Our Case Number: ABP-310286-21

Re: Railway works and all works necessary to eliminate and, where necessary, upgrade seven numbered level crossings and carry out all associated and ancillary works along a 24-kilometre section of the Dublin to Cork Railway Line.
Fantstown, Thomastown, Ballyhay, Newtown, Ballycoskery (Ballyhea Village), Shinanagh and Buttevant, Co. Cork and Co. Limerick.

Re: Dublin to Cork railway line; elimination and upgrade of Level Crossings
between Limerick Junction and Mallow Order 2021.

MHL Project Number:	21092TT
Project Title:	Railway Order – Dublin to Cork Railway Line (Elimination & Upgrade of Level Crossings between Limerick Junction and Mallow)
Author:	Brian Murphy, BE CEng MIEI
Date:	30/06/2021
Subject:	Third Party Submission – Dr Michael Kennedy & Dr Deirdre O'Reilly
Document Status:	Draft Internal / Not for Circulation

DRAWING 1

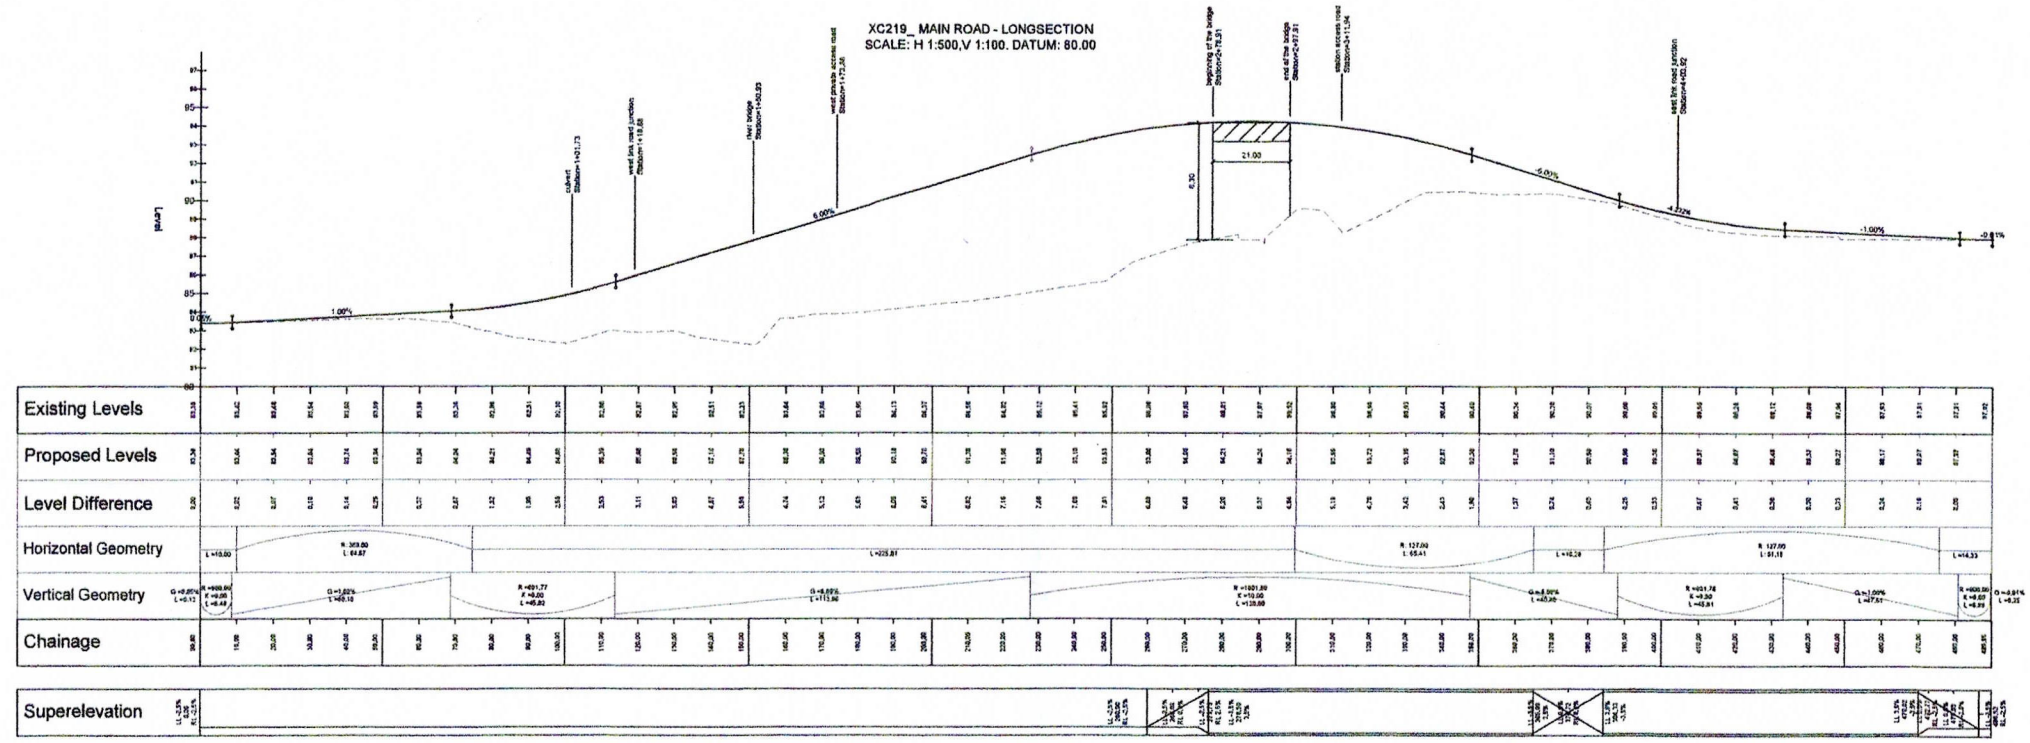
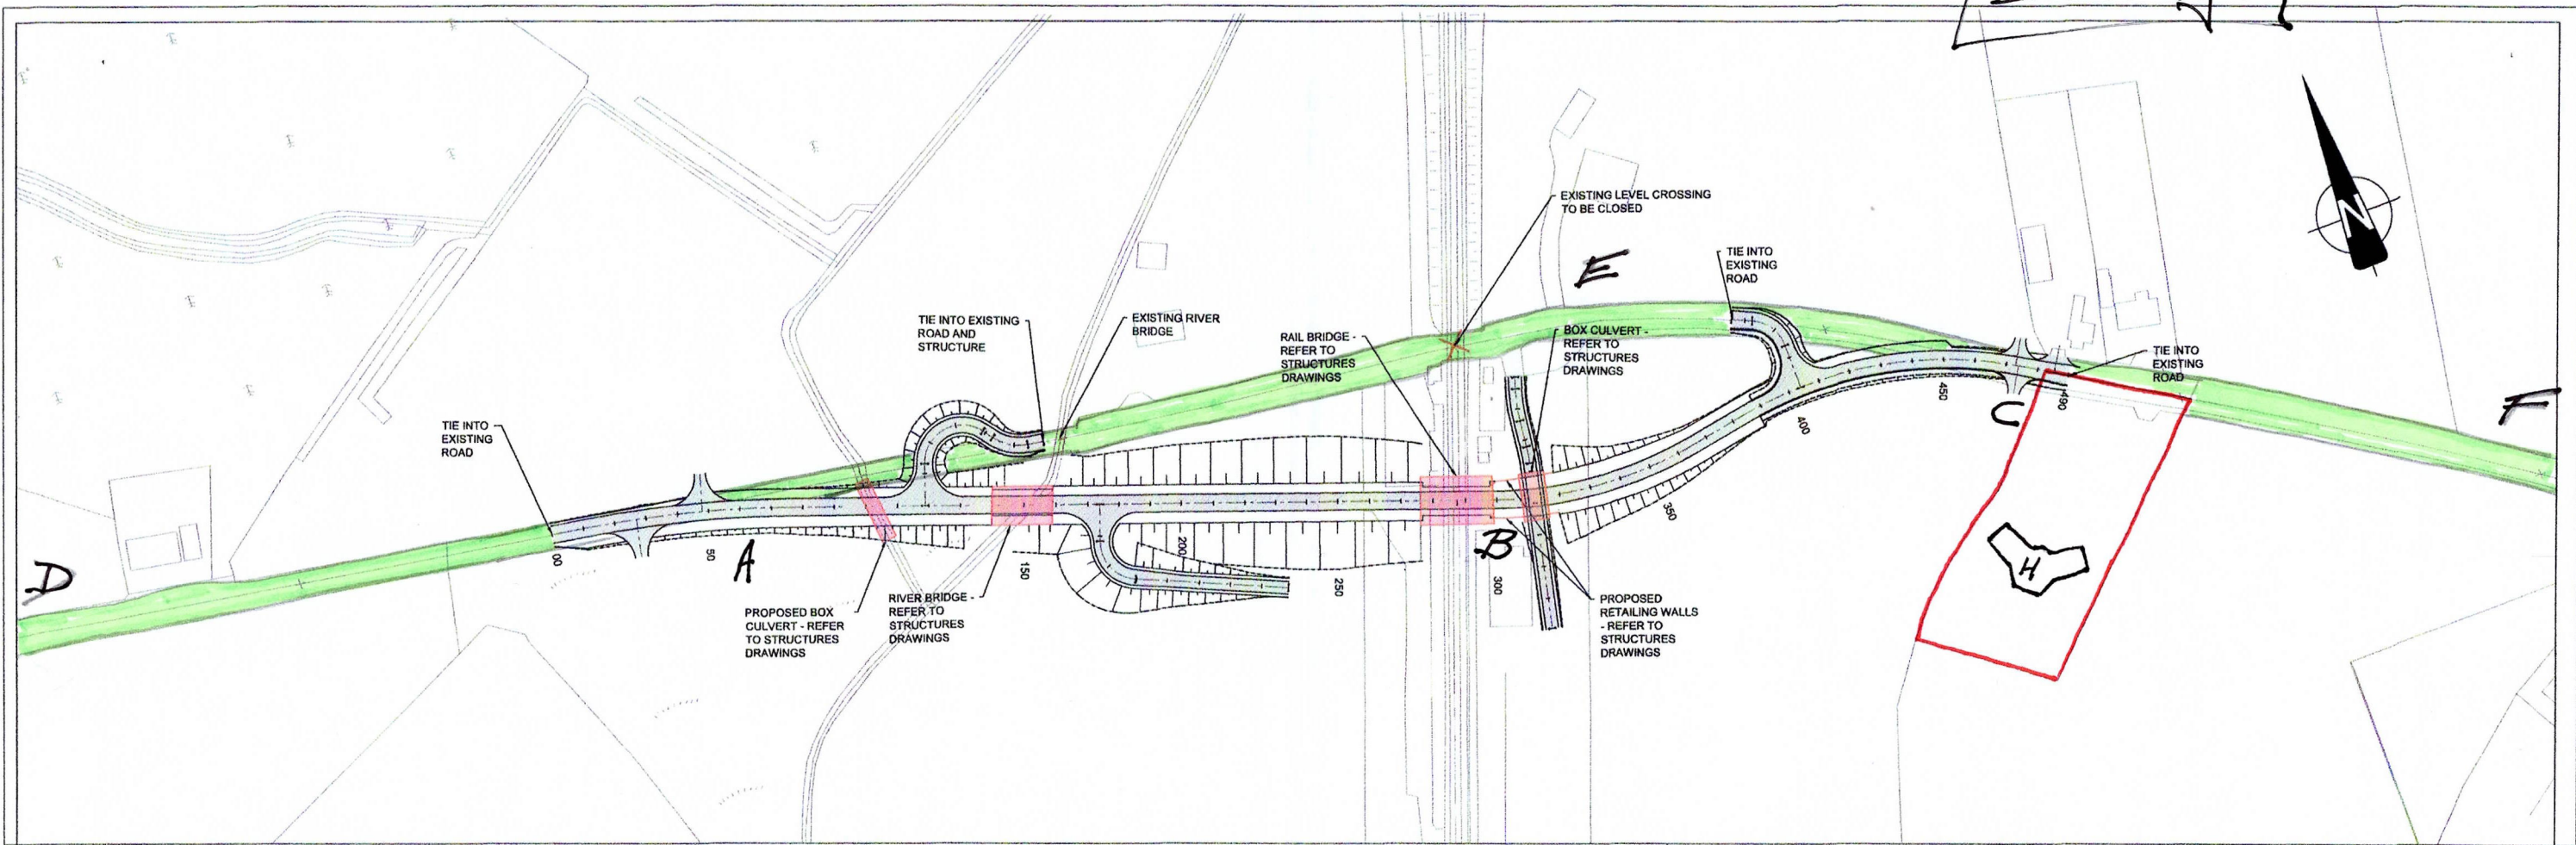
It will be noted from Drawing 1 that it is proposed to re-route the road, particularly, the section between B and C, closer to our Clients' house.

It will also be noted that whereas the existing road is either level with or below the level of our clients' property, the new road would continuously rise from the existing level of 87.86m at C to a new level of 94.69 at B (see levels on Drawing 2)

Rather than remain relatively level, traffic would now have to ascend and descend the slopes on both sides of the bridge shown on Drawing 1.

In addition, on the new road, traffic would have to cross the proposed new culvert on our Clients' side of the bridge and the bridge itself which, clearly, would generate more noise than traversing a ground-supported road.

It will be noted that traffic using the existing road (coloured green) is orientated away from our clients' house.

However, were to works to proceed, as will be noted from Drawing 1, vehicles driving Eastwards would, between about the areas marked A and B, be orientated in the direction of our Clients' house.

Whilst it appears from the slope shown on the Longsection on that drawing that for part of the distance headlights would be angled upwards, it is clear that for a section of about 50/100 metres they would be angled directly towards our client's house.

This would be exacerbated by the fact that the level of the new road in the areas in question would be up to more than 8 metres higher than the level of our clients' property.

It is clear that were the works to proceed the combination of the re-routing/re-orientation of the road and the height of it, as outlined above, would result in our clients' property being overlooked, particularly, by vehicles, cyclists and pedestrians on/near the proposed bridge and on the higher sections of the road between B and C.

Project:	CORK LINE LEVEL CROSSINGS		
Component:	RAILWAY ORDER SCHEME DRAWING		
Title:	PROPOSED SITE PLAN - XC219 BUTTEVAULT - SHEET 2 OF 2		
Designed:	SK	File Name:	Drawing No.
Drawn:	JR	Original scales:	32111000-JAC-LUH-XC219-DR-CH-0004(ii)
Checked:	EMD	Scale:	DEC '20

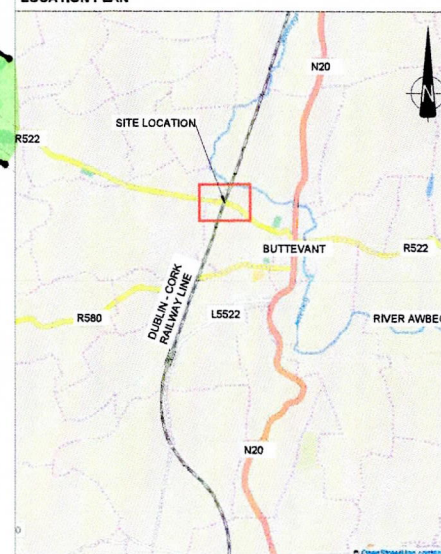
In addition, as will be noted from Drawing 2 attached, 10 lamp posts are proposed in an area adjacent to our Clients' house some of which will have a height at their base of about 7 metres above the level of our clients' property.

When the height of the post itself is added to that, it is clear that there would be considerable glare from these lamp posts as well in respect of which there is also no consideration or provision.

Application drawing (Ref 32111000-JAC-LUH-XC219-DR-CH-0004(ii), Proposed Site Plan - Xc219 Buttevant - Sheet 2 OF 2) indicates that a footpath is to be provided from our client's property northwards. This is unclear and clarity should be provided on same. From chainage 410m westwards a "pavement/verge" is to be provided as far as the bridge. No roadside space is provided over the bridge on the southern side of the road. A reduced "pavement/verge" width is provided on the opposite side of the road. Local residents currently enjoy connectivity northwards as far as railway crossing. Connectivity across the rail tracks and onwards, whilst not formally provided for, is catered for by way of a sympathetic roadside boundary, appropriate to such a residential location.

A safe continuous footpath should be provided through the length of the road alignment to accommodate safe access for local residents along the route.
